No. 61-12090

MEMORANDUM

RE: *Response to IDWR memos regarding aquifer recharge along I-84 corridor from Boise to Mountain Home*

Figure 1. Ground water surface elevation contours (50-ft).

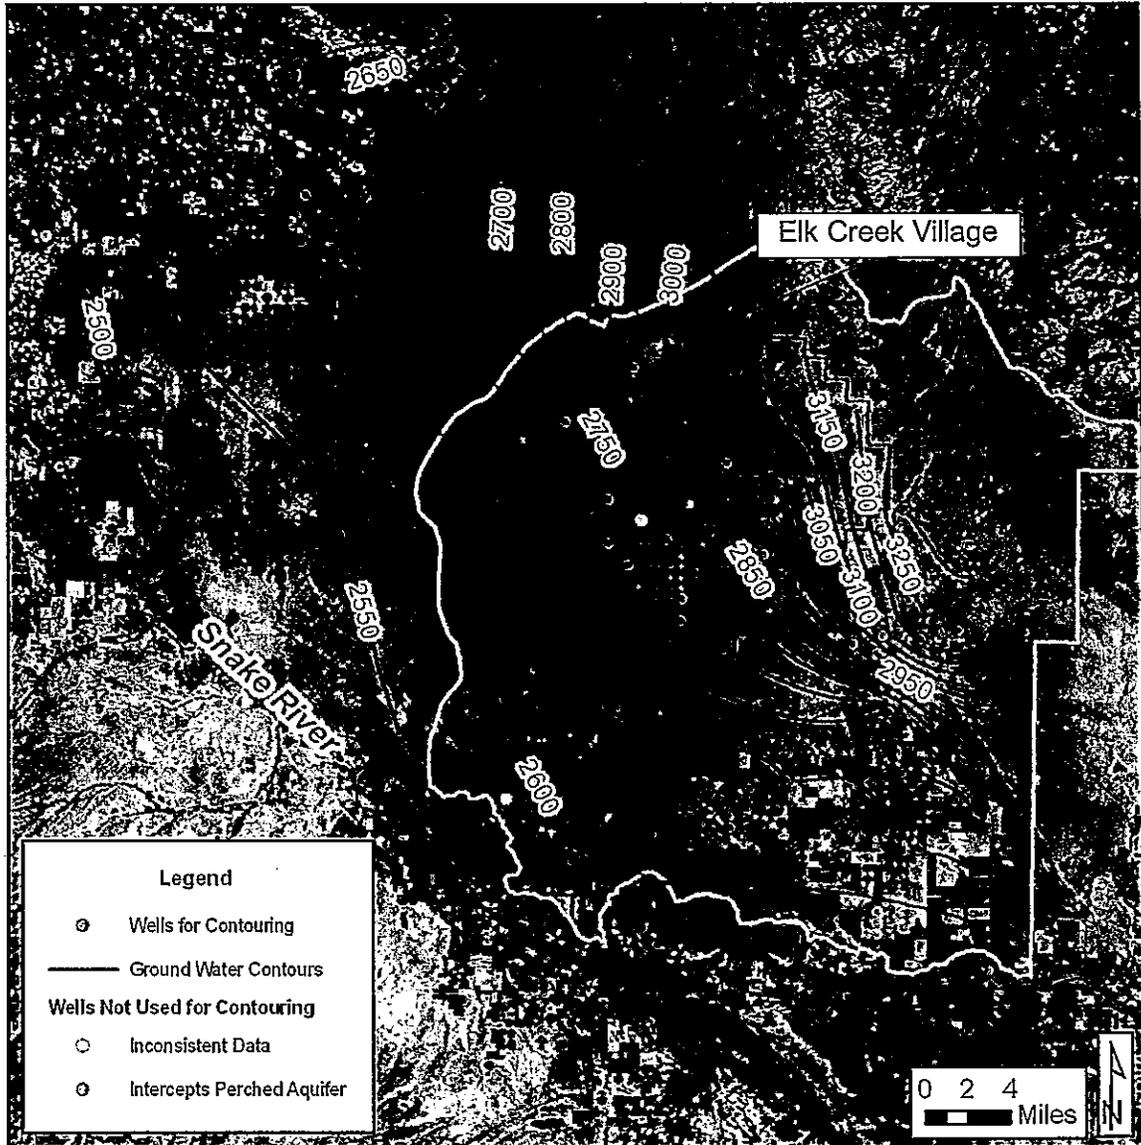
- a. Ground water in the vicinity of the Elk Creek Village flows in a southwesterly direction perpendicular to the water level contours shown in Figure 1. A cone of depression emanating from the Cinder Cone CGWA (coarsely illustrated with the 50-foot contours shown in Figure 1) does not intercept flow from the Elk Creek Village area. Furthermore, a water level change map in Figure 1 of the Tesch and Vincent memo does not show declines reaching the Elk Creek Village area.

- b. It is noteworthy that pumping in the Cinder Cone CGWA has not reached the Elk Creek Village area in 40 years of pumping. The extension of a cone of depression from the Cinder Cone area may be, in part, precluded from extending to the Elk Creek Canyon area by leaky hydraulic boundaries associated with faulting parallel to the Danskin Mountain Front (Figure 2). Seismic geophysics proposed for the summer of 2009 may help identify faulting in this area.

Figure 3. Theoretical drawdown after a period of one year.

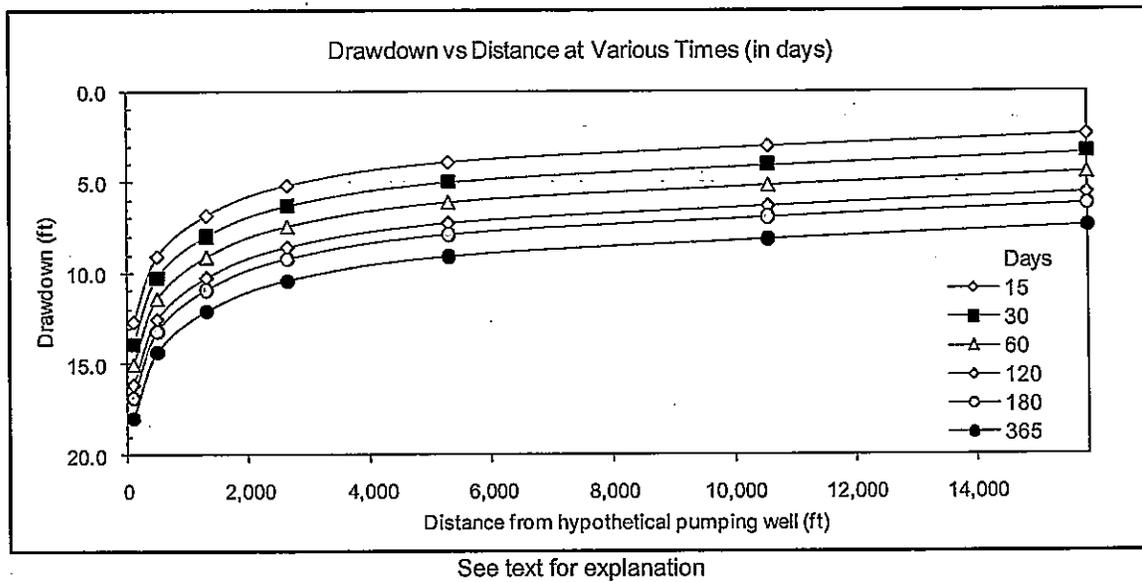
storativity of 0.005, and an average withdrawal rate of 0.8 cfs (which provides for an annual withdrawal of 577 AF under the Elk Creek Village application), a water level decline of up to about 8 feet is possible at a distance of 2 miles after 1 year³. (Figure 3). This shows the possible extent of a capture zone. Note, however, that any recharge to the aquifer during the year of withdrawal would reduce (or eliminate) this long-term drawdown predicted using the Theis solution. The Theis solution, like the WhAEM model, is a 2-dimensional solution that does not account for boundary effects, vertical ground water flow, or hydraulic discontinuities.

- iii. The WhAEM model, while appropriate for some wellhead protection analyses, is not ideal for defining recharge capture areas in complex hydrogeologic areas because of the dependence on pre-defined recharge rates and other simplifying assumptions.

We anticipate minimal impacts to existing wells as a result of proposed withdrawals under application 61-12090. Based on a review of drillers' reports listed in the IDWR well construction database, there are 1, 5, and 15 wells within $\frac{1}{4}$, $\frac{1}{2}$, and 1 mile of the Elk Creek Village property, respectively. The single well within $\frac{1}{4}$ mile of the property is controlled by the Elk Creek Village property owners. Potential water level declines will be significantly less than the 10 feet shown in Figure 3 because of recharge in the Elk Creek Village area.

Figure 4. Soils in the Elk Creek Village area.

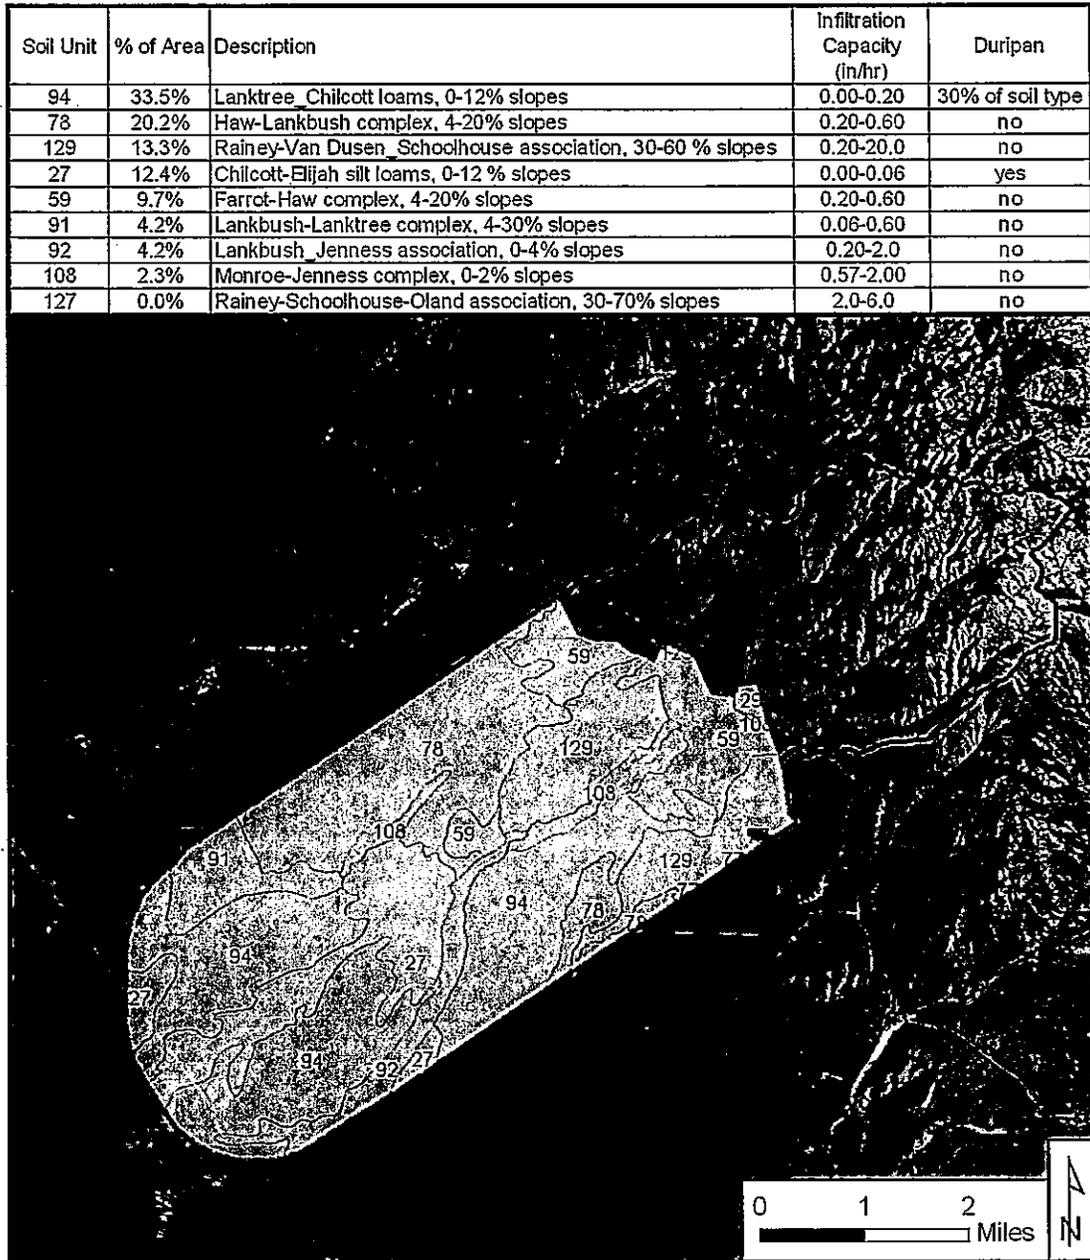
- i. Soils with duripan layers cover about 22 percent of the estimated sedimentary infiltration area for the Elk Creek Village.
 - ii. Soil unit 27 (Figure 4), which has low-permeability (i.e., duripan) characteristics, covers about 12.4 percent of the sedimentary portion of the Elk Creek Village infiltration area.

Figure 5. Assumed capture area for areal infiltration and contributing watershed areas for surface channel seepage. Surficial geology from Bond and Wood, 1978.

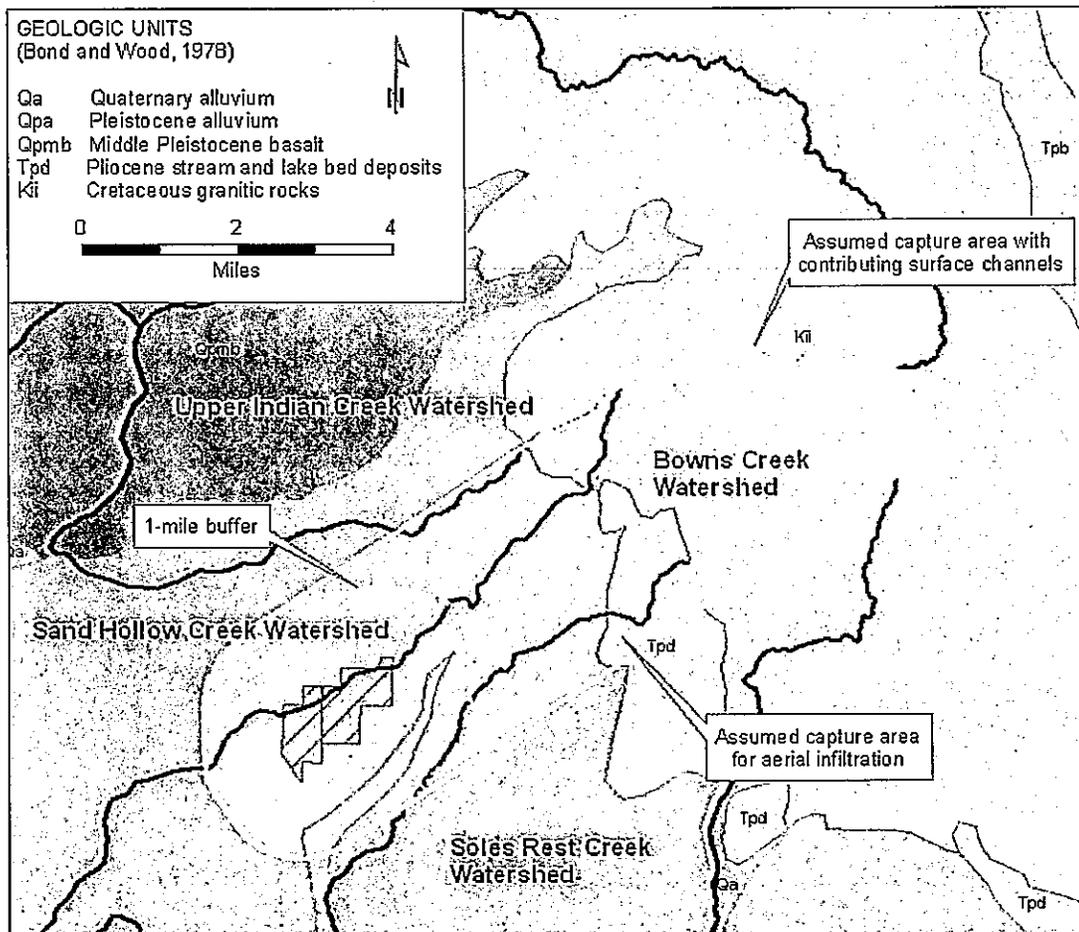
Four watershed areas define surface water flow in and upgradient of the property, shown in Figure 5. However, these surface water drainages do not necessarily define subsurface flow divides. Aquifers in the area extend beyond, and can be influenced by, recharge and discharge from areas outside of these watershed areas. For this analysis it was assumed that the capture area for aquifers in the project area and the area of well withdrawals near the Elk Creek Village property is the area upgradient and within approximately 1 mile of the Elk Creek Village property but limited by contacts with granitic rocks (Figure 5). The assumed capture area for areal infiltration is approximately 12,000 acres.

primarily sedimentary areas. These upper watershed areas include approximately 5,400 additional acres (Figure 5).

1. The recharge capture zone was decreased from a 2-mile radius around the Elk Creek Village property to a 1-mile radius.
2. Wintertime evapotranspiration was added to the annual evapotranspiration.
3. Evapotranspiration estimates were made using data from ET Idaho.

Figure 7. ET Idaho weather stations.

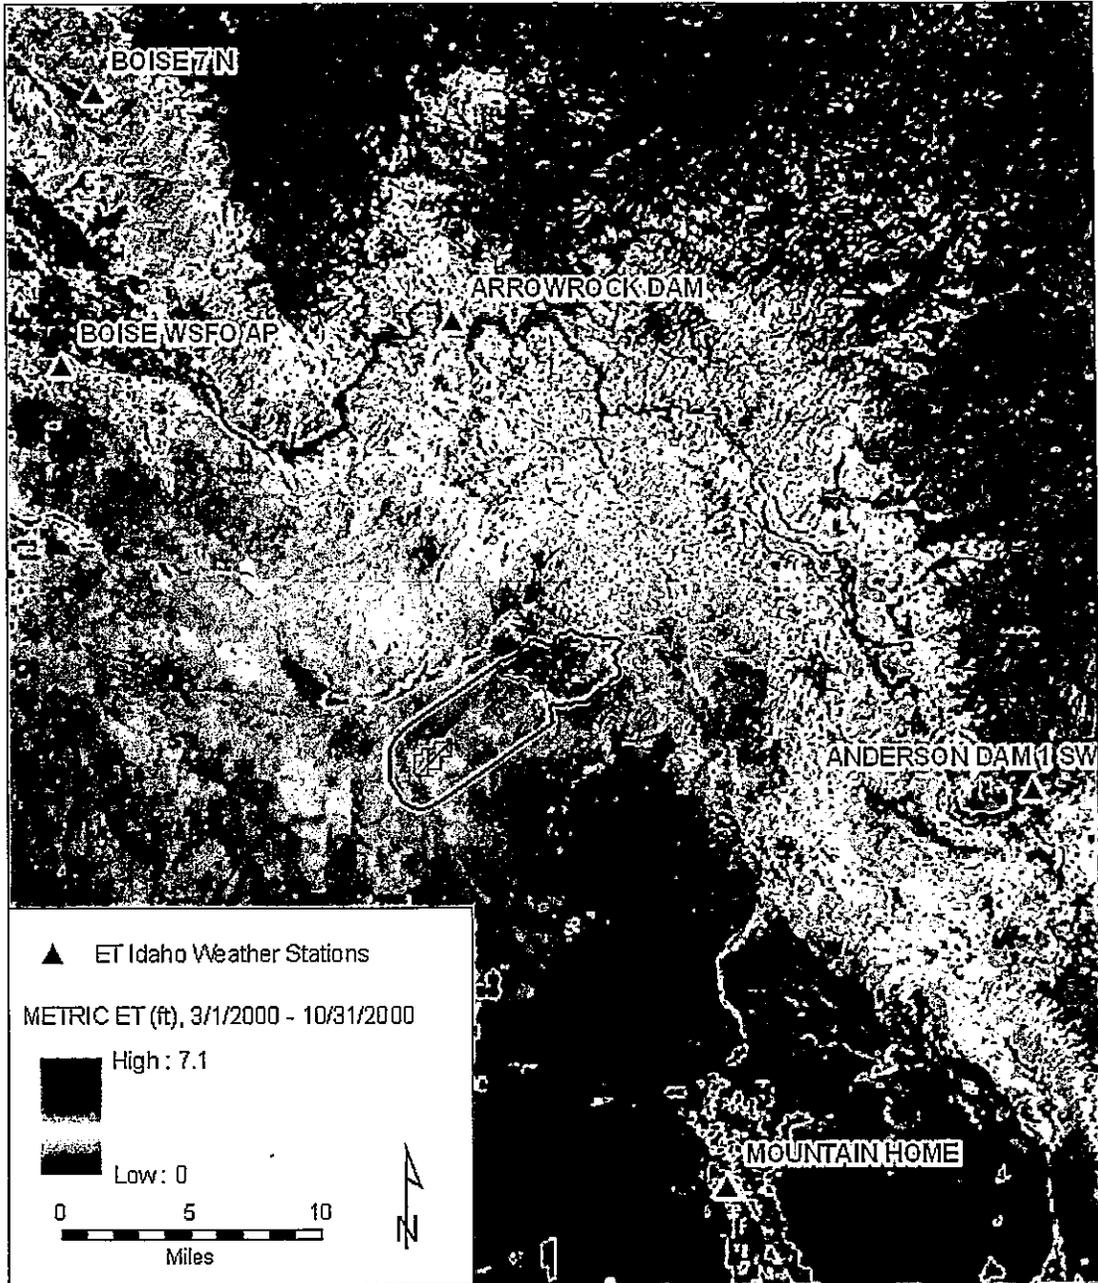
approximately 9.0 inches (or approximately 0.75 AF/acre). From ET Idaho, the average evapotranspiration during the wintertime months (November through February) for sage brush and rangeland at five area weather stations (Figure 7) is similar (ranging from 1.85 to 2.00 inches). An assumed average value of 1.93 inches during the wintertime months yielded an additional 2,780 AF of evapotranspiration for the Elk Creek Village area, resulting in a total estimated evapotranspiration of approximately 15,900 acre feet.

The use of Anderson Dam weather station data may be conservative in the sense that it could yield a higher estimate of evapotranspiration than actually exists. This is because METRIC evapotranspiration data (Figure 7) show lower evapotranspiration rates in the Elk Creek Village area than near the Arrowrock Dam and Anderson Dam locations. While METRIC data may have inherent error in non-agricultural areas (resulting from lack of calibration), the relative spatial differences are likely to be relatively accurate⁹.

Figure 1. SPF and IDWR areas of interest. The proposed Mayfield Townsite development is outlined in black.

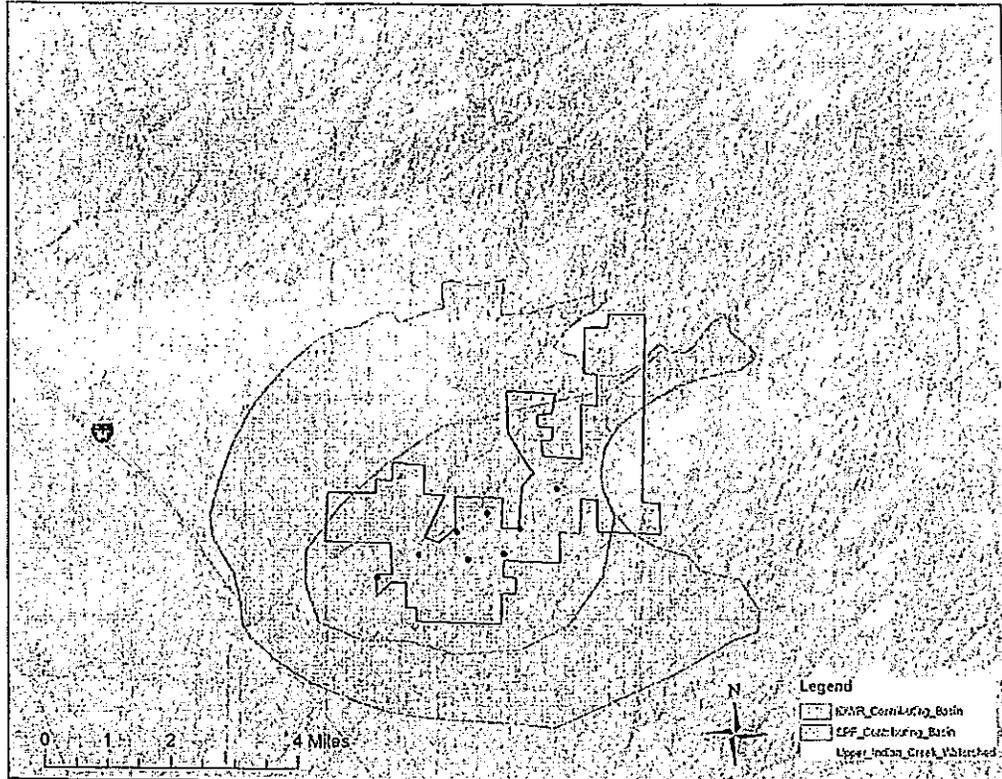
In the absence of a well-developed hydrogeologic conceptual model, the contributing basin was arbitrarily assumed by SPF as a two-mile buffer from each of the proposed wells. The area is truncated by the geologic contact between the granitic uplands and the basin geologic units (Figure 1). SPF's resulting capture area encompasses approximately

27,500 acres (SPF, 2007, p. 19). Even though arbitrary, the 2-mile capture area presented by SPF is one estimate of the recharge area for the aquifer of interest.

As shown in Figure 1, the resulting 10-year hydraulic capture zone is considerably smaller (18,000 acres) than the "*contributing basin for aquifers in the project area*" (p. 19) that was assumed in the SPF analysis (27,500 acres). The area delineated by IDWR is similar to the area assumed by SPF in the fact that the 10-year travel time was selected arbitrarily. Although actual pumping rates and aquifer properties were used in defining the area, hydraulic gradients and aquifer boundary conditions were not included in the modeling process. Therefore, the resultant area represents the theoretical area in which the production wells would withdrawal water from a flat, infinite aquifer in a 10-year timeframe.

Figure 3. Hydrographs of Indian Creek and Cottonwood Creek. The runoff volume in Indian Creek was estimated by summing the areas of the shaded rectangles. Cottonwood Creek hydrograph was downloaded from <http://waterdata.usgs.gov/nwis/sw>.

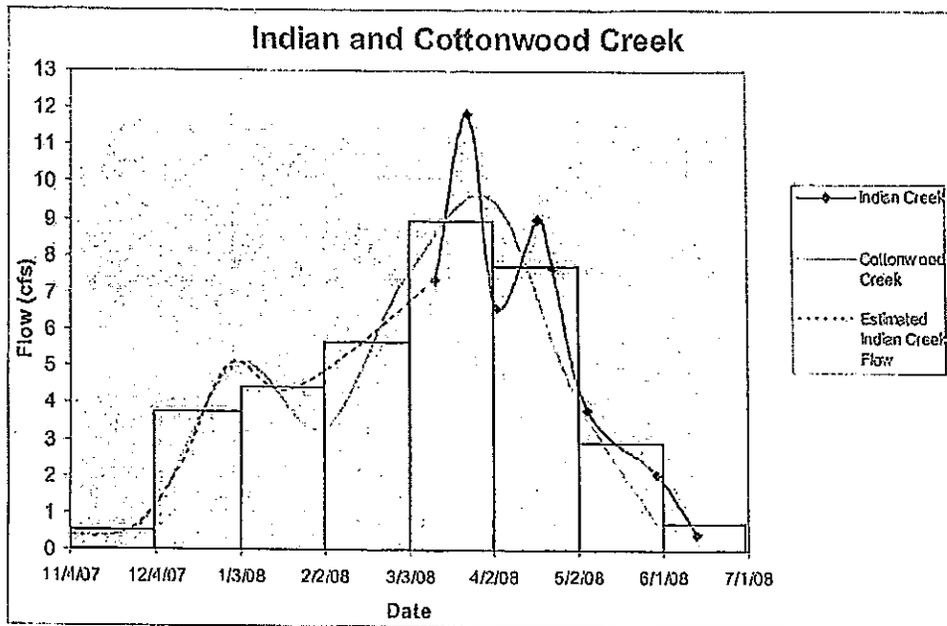
With average to above average snow pack conditions in the Indian Creek watershed this year (2008), we consider the measured flow rates in Indian Creek to be representative of a typical runoff season. However, based on the hydrograph for Cottonwood Creek (USGS Station 13204640), a creek north of Boise that drains a basin of similar physical characteristics (elevation, vegetation, slope, aspect, weather conditions), the runoff season is considerably longer than 3 months. A continuous record of flow in Cottonwood Creek was available for the same period (March-June) as our field measurements. The flow rates are remarkably similar for the period of overlapping measurements (Figure 3). As such, and because the Cottonwood Creek drainage experiences similar weather and has similar physical characteristics, the early season Cottonwood Creek flow data were used to extrapolate the flow data for Indian Creek. The resulting estimated runoff volume for Indian Creek is 2,065 acre-feet for a runoff season that lasts 7 months (Table 3). This is a considerably longer runoff season than the 3-month season that was assumed by SPF.

Based on field observations, the three day temporary flow rate of 100 cfs that SPF included in the water budget was excluded from the IDWR estimate. Coarse sand deposits can be observed along the entire length of the channel down to Indian Creek Reservoir, indicating that not all of the surface flow seeps into the aquifer within the capture area during high flow events.

Figure 4. Water levels in three wells near the Mayfield area with current monitoring data.

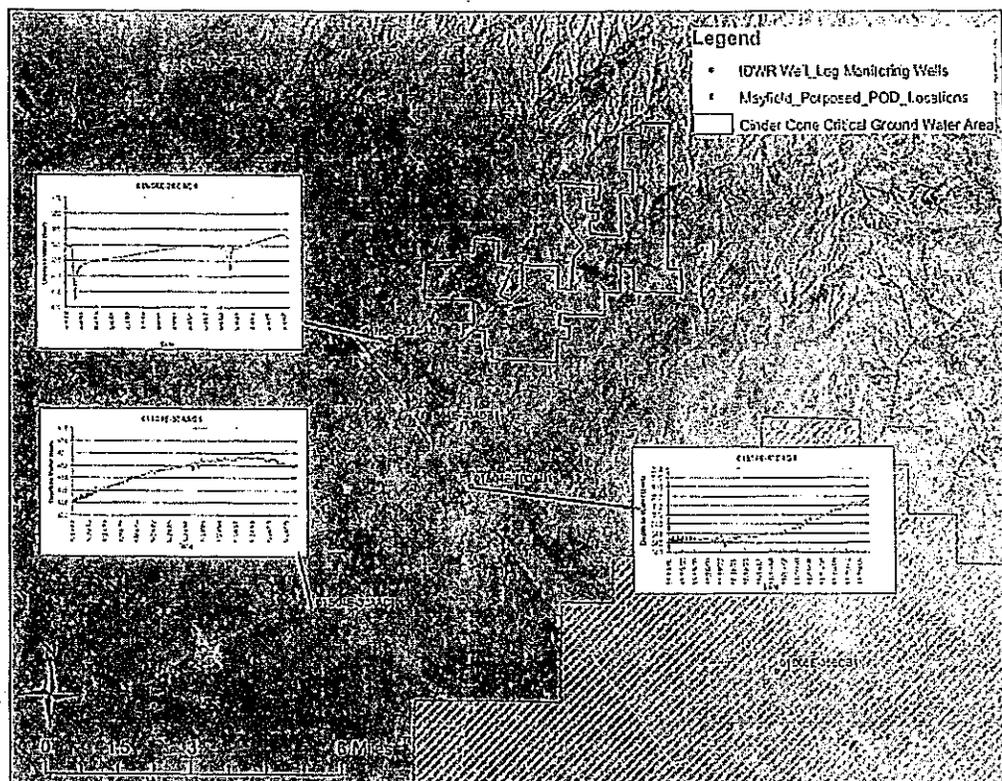
SPF indicates that most water levels in the Mayfield area are either stable or slightly rising (SPF, 2007, pgs. ii, v, and 13). This conclusion is based on IDWR monitoring well data for 16 wells within a 10 mile radius of the development. However, only three of these wells have monitoring data through 2007. Of these three wells, two appear to have increasing trends and the third well appears to be experiencing a declining trend (Figure 4).

It is agreed that the general water level conditions in the Mayfield area are stable or slightly increasing. However, the significance of this trend should not be overemphasized, as it has been shown that the aquifer in this area has historically not experienced significant withdrawal volumes. A significant increase in ground water use in the area has the potential to create declining water levels, similar to those experienced in the Cinder Cone Critical Ground Water Area.
